Network Video Recorder

Version: V4.30.000 build 200508

Release Note

Firmware Basic Information	Firmware Version:	V4.30.000build200508
	SDK Version:	V6.1.4.20_build20200320
	Play Library:	V7.3.7.39
	Web component:	V4.0.1 build200507
	OpenSDK Version:	V2.5.0

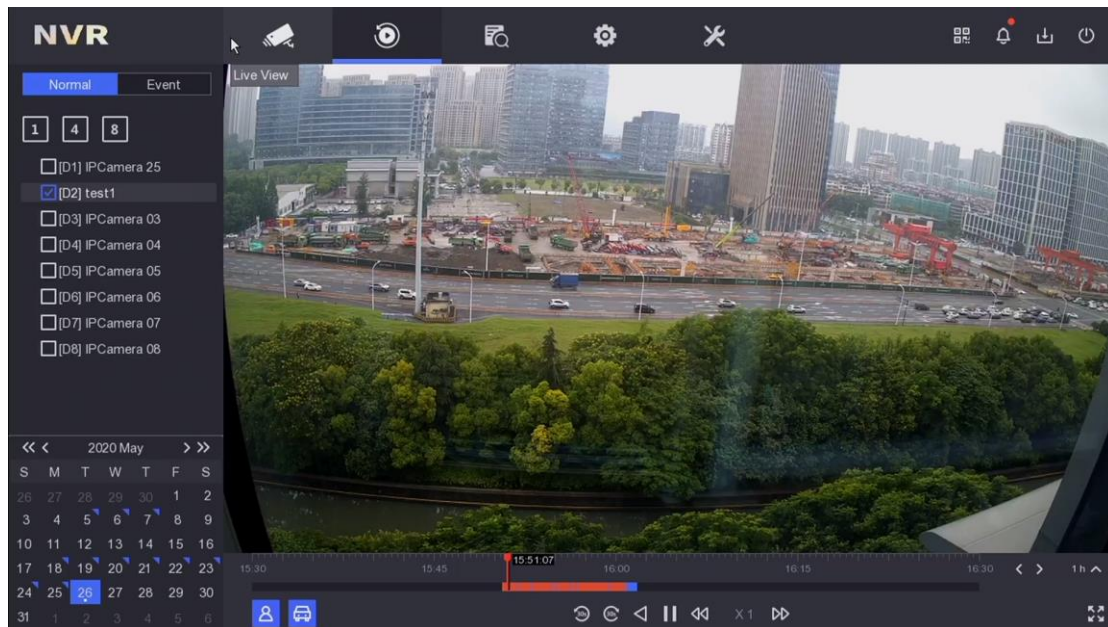
The smart playback interface for local playback and the remote ordinary playback interface add the option of human body-vehicle filtering. After checking, the human body-vehicle video information will be marked in red on the progress bar.

2. 【Support access in ISUP 5.0 protocol】

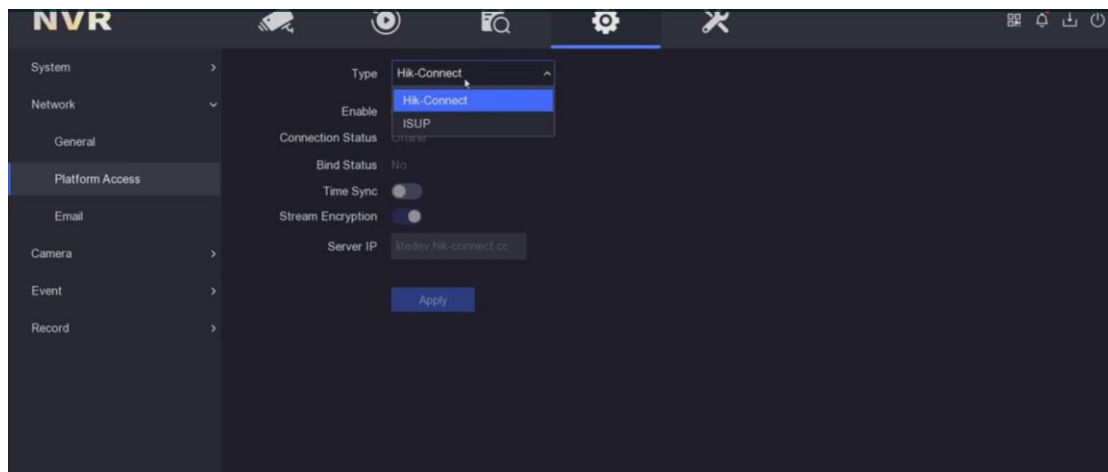
- 1) Overseas product support adding ISUP 5.0.
- 2) Support the configuration of preview, playback, two-way audio and FTP upgrade.

3. 【Support Hik-Connect to enable One-Key Do Not Disturb function】

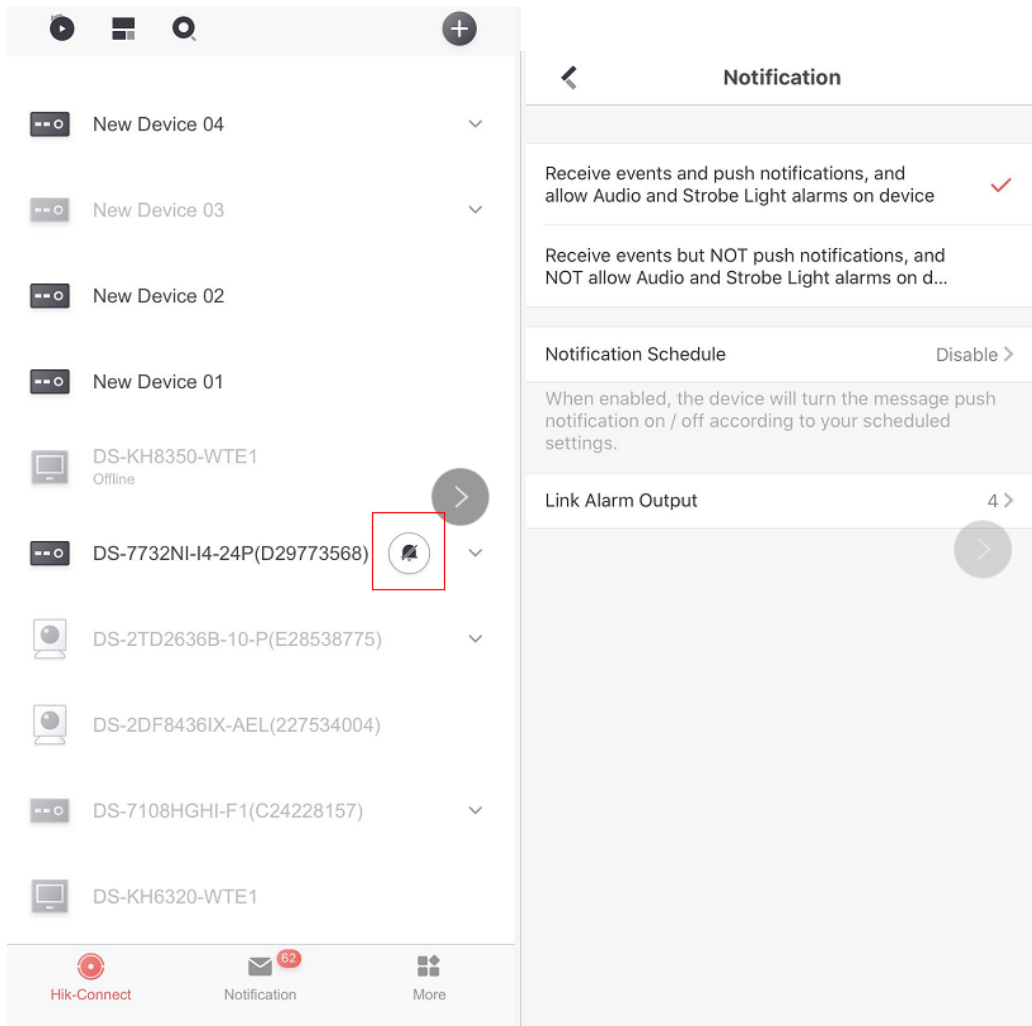
- 1) After Hik-Connect enables the One-Key Do Not Disturb function, all event linkage action will be cancelled.

4. **【Support Hik-Connect / GuardingVision to scan NVR QR code to recover password】**

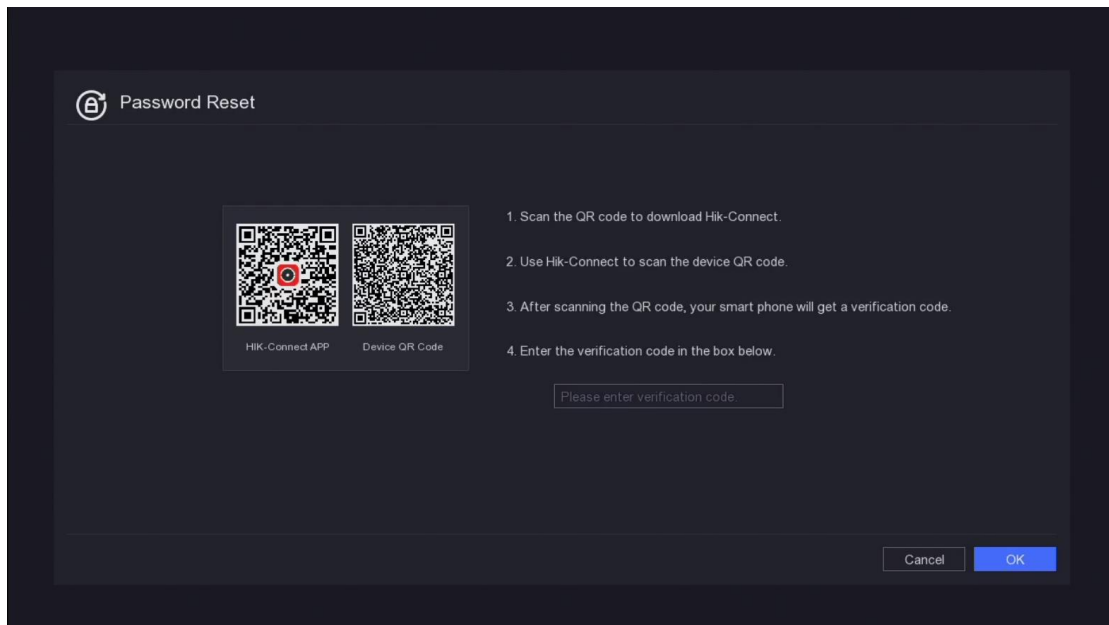
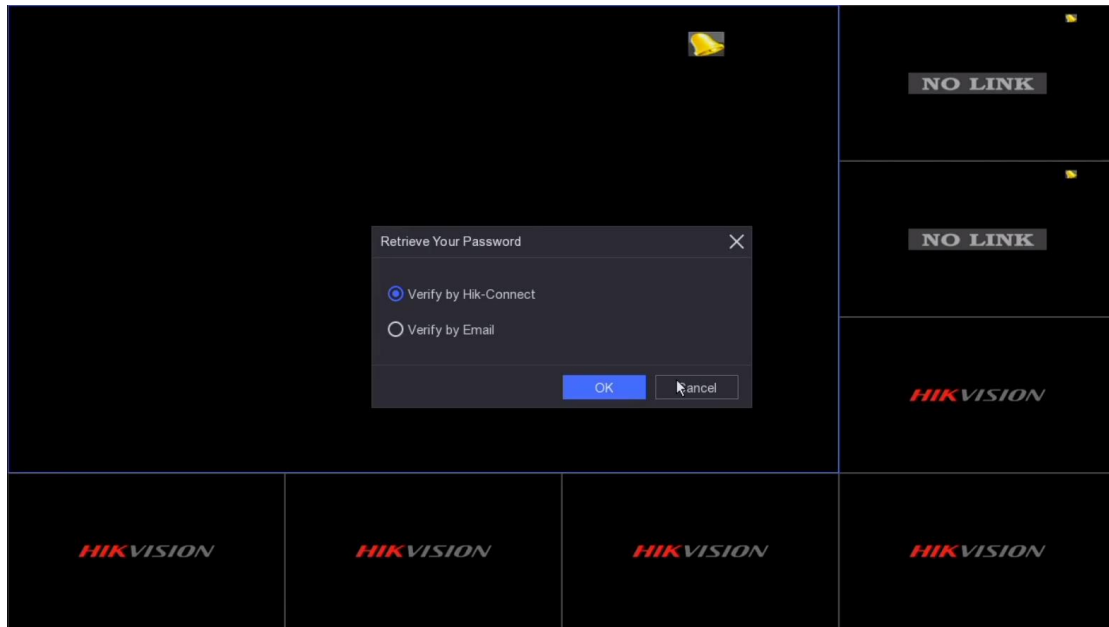
1) Support local HC / GV scanning QR code and mailbox to recover password, Local GUI delete the recovery way of GUID and security issues; WEB still retain GUID, security issues and mailbox to recover password.

2) Only the NVR that has been bound to the HC / GV will display the option to scan the code to recover the password.

3) Only the NVR-bound HC / GV client account can successfully recover the password.

4) Require HC/ GV v4.3.0 and later.

5. 【Support GUI local online upgrade by Hik-Connect】

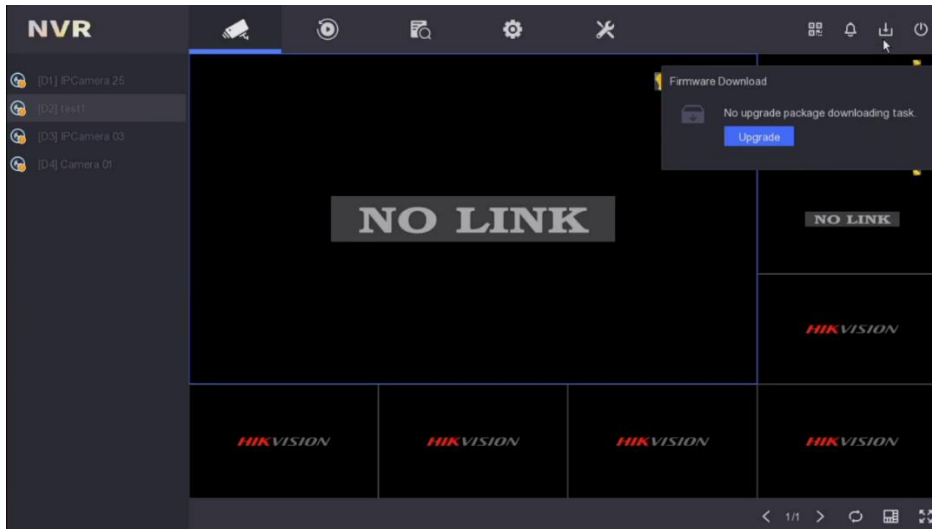
1) Support IE, GUI local Hik-Connect online upgrade.

2) Support HC remote upgrade

3) Remote upgrade will be pushed to the main menu interface, there will be a red dot prompt in the upper-right corner of the main interface

6. 【Support event recording search in Hik-Connect client】

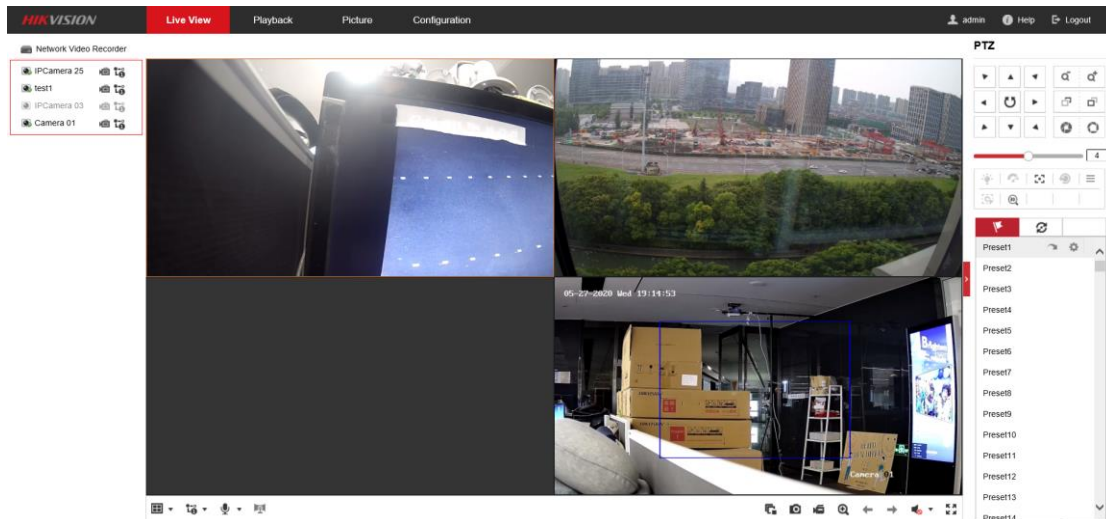
Support event recording search in Hik-Connect, continuous recording progress bar with light orange and event recording progress bar with deep orange.

10. 【Optimization of PoE exception information display】

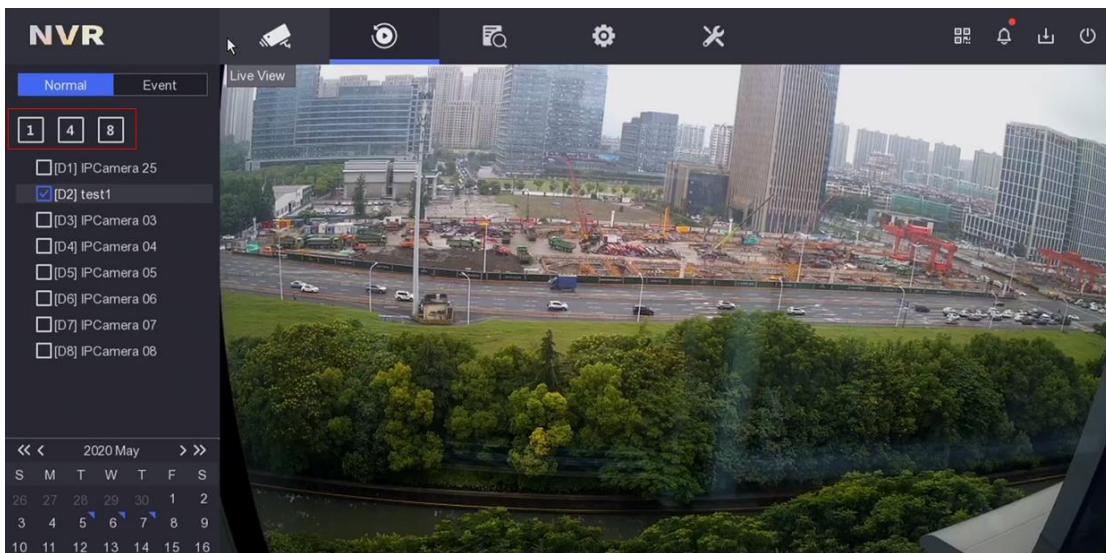
- 1) When switch connect to NVR PoE port, no short-circuit or error information will display.

2) Cameras that link with Switch which connect to NVR PoE port, could also connect to NVR through this switch.
